Service Bulletin

Bulletin Number: **SB 22-356**
Release Date: **October 6th, 2022**
Distribution: **Heil Dealers, Heil Technical Services, Heil Customer Care**
Subject: **Half/Pack® Vertical Arm Welds**

Figure 1 Area of Missing Welds

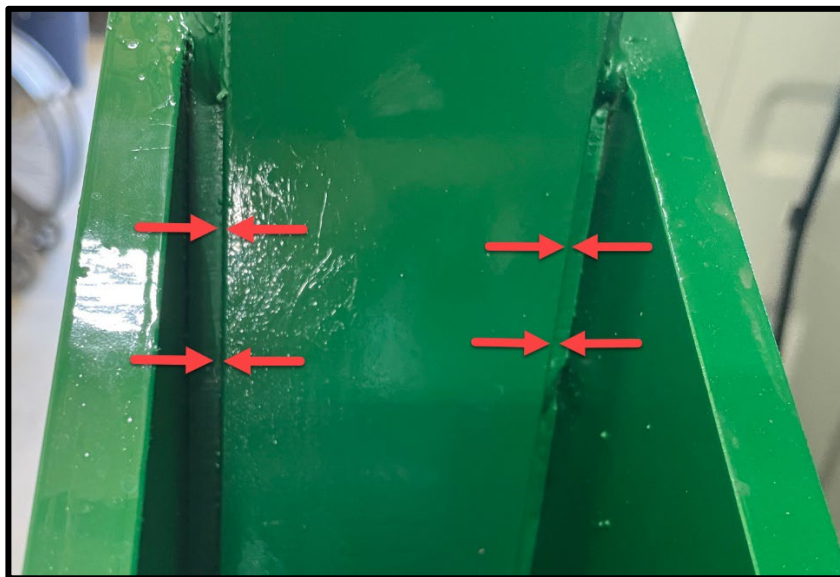
Inspect the weld area(s) on the Half/Pack® AFL arms to make sure that they are properly welded. See **Figure 1 Area of Missing Welds**.

Figure 3 Welded Spacer

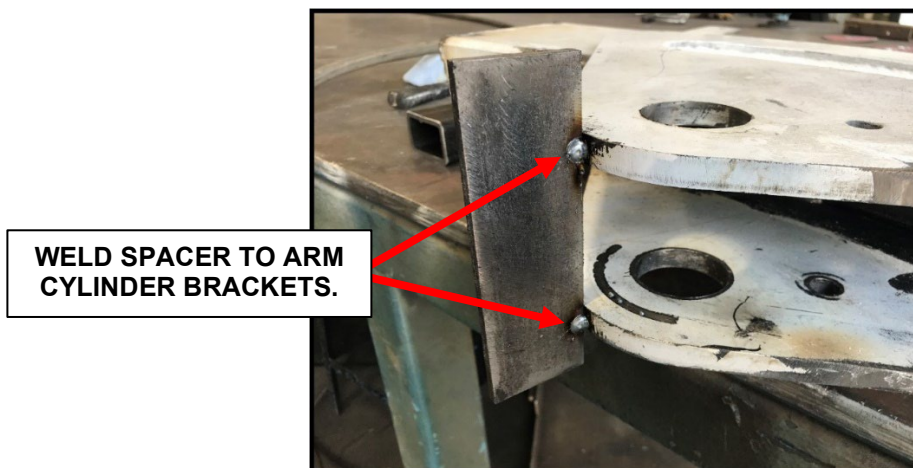
- (1) If upon inspection, the correct welds are not located on the arms, cover the painted areas (outside of repair area) on the unit as much as possible for minimal rework.
- (2) Keep arms attached to the body. With the arms down, remove the cylinder pins to drop the arms to the ground.
- (3) Brace the cylinder brackets with steel to keep the brackets from pulling in towards each other. See **Figure 3 Welded Spacer**.

NOTE: Use Porter Power to readjust the cylinder mounting plates as needed.

Figure 4 Remove Spacer Bracket

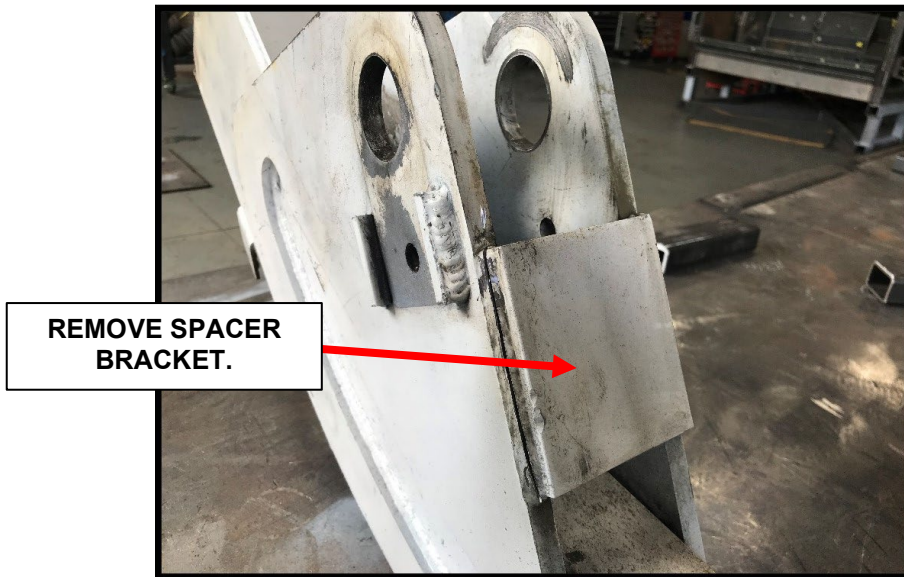
- (4) Remove spacer block for clearance. Use cutting wheel to remove the spacer. **DO NOT use a torch or plasma to remove the spacer.** This will minimize the heat input. See **Figure 4 Remove Spacer Bracket** and **Figure 5 Removed Spacer Bracket**.

Figure 6 Grind Back 2 Inch Minimum

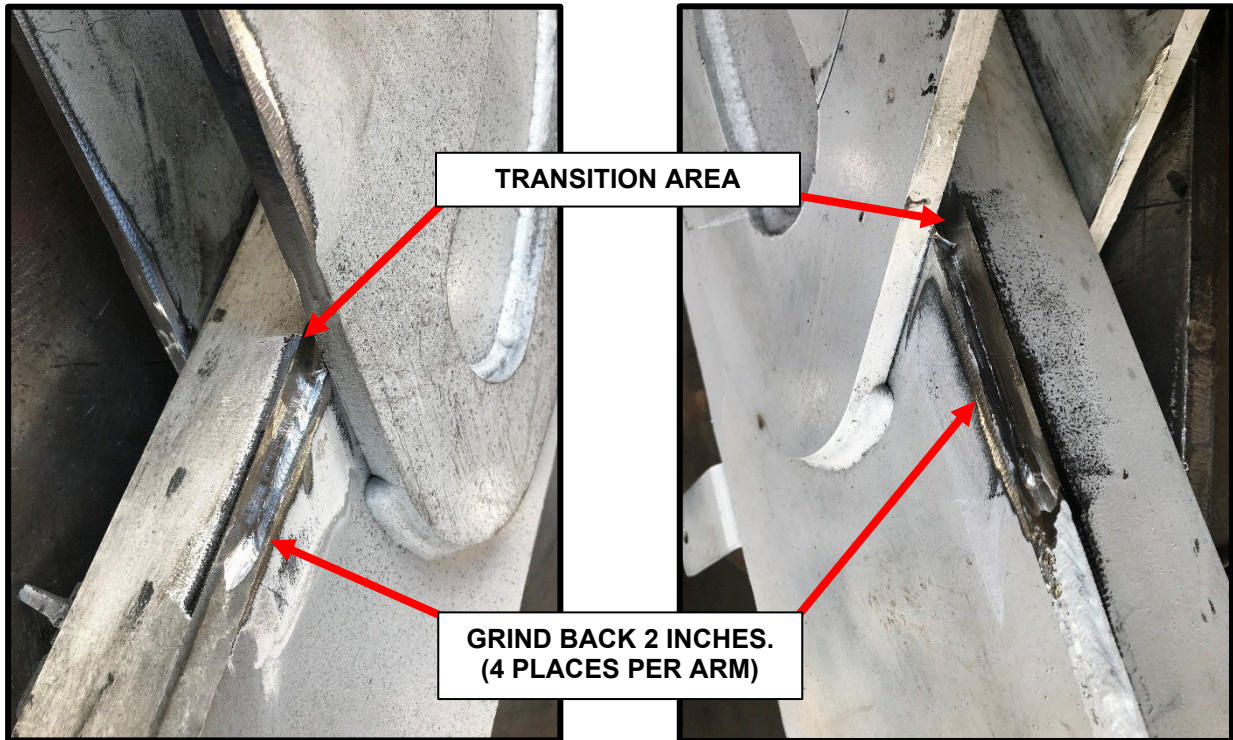
- (5) Grind out the weld 2 inches at a minimum from the end (4 places per arm). Remove caulk as needed. See **Figure 6 Grind Back 2 Inch Minimum**.

Figure 8 Start and Stop Weld Directions

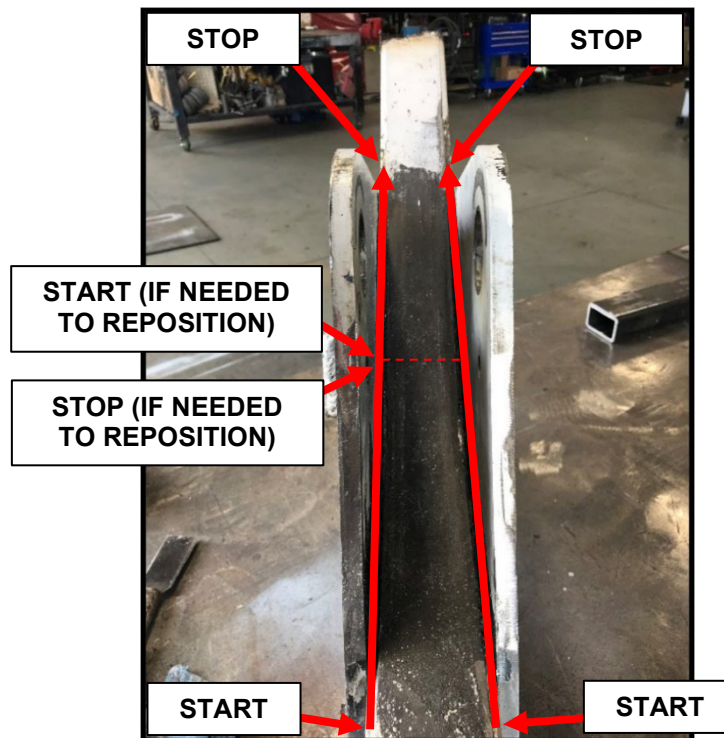
- (7) Weld in the vertical position to ensure proper penetration and side wall fusion. Start from the bottom and weld all the way up. **DO NOT STOP** your weld. If there is a need to stop for repositioning, stop in the center of the bracket. See **Figure 8 Start and Stop Weld Directions** and **Figure 9 No Starts / Stops at Transition Weld**.

NOTE: Ensure the weld is continuous through the transition.

- .045 ER70S-6
- 26V to 28V
- 450 IPM to 500 IPM
 - Horizontal – Overhead – Vertical Up
 - NO Vertical Down Welding

- 1/8" Electrode
- DC Electrode Positive
- E6010 or E6011
- 80 Amps to 90 Amps
 - Horizontal – Overhead – Vertical Up
